Product Change Notice

PCN#: EE-PCN23017

07/21/2023

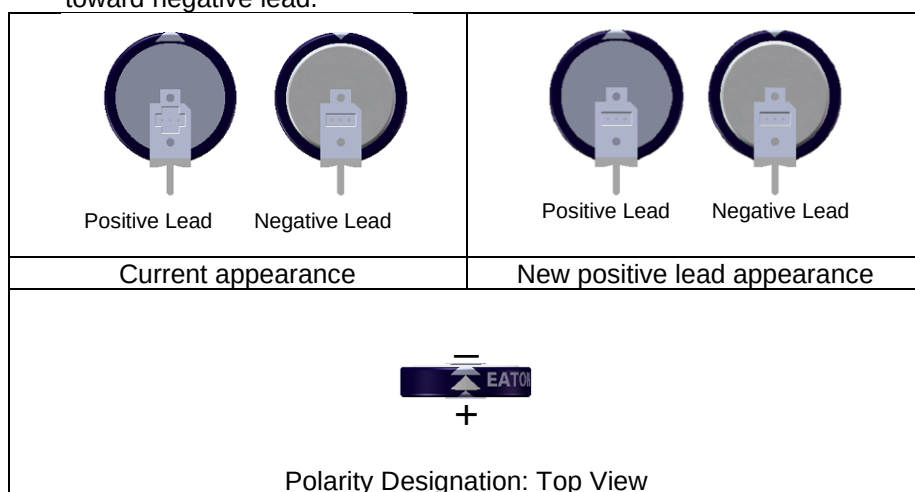
1. Tolerance of dimension P changing from ± 0.3 mm to ± 0.5 mm
2. Change of positive lead appearance. Polarity will continue to be determined by sleeve design pointing toward negative lead.

1. Specification to match actual production.
2. Quality improvement to avoid confusion with marking on the lead.
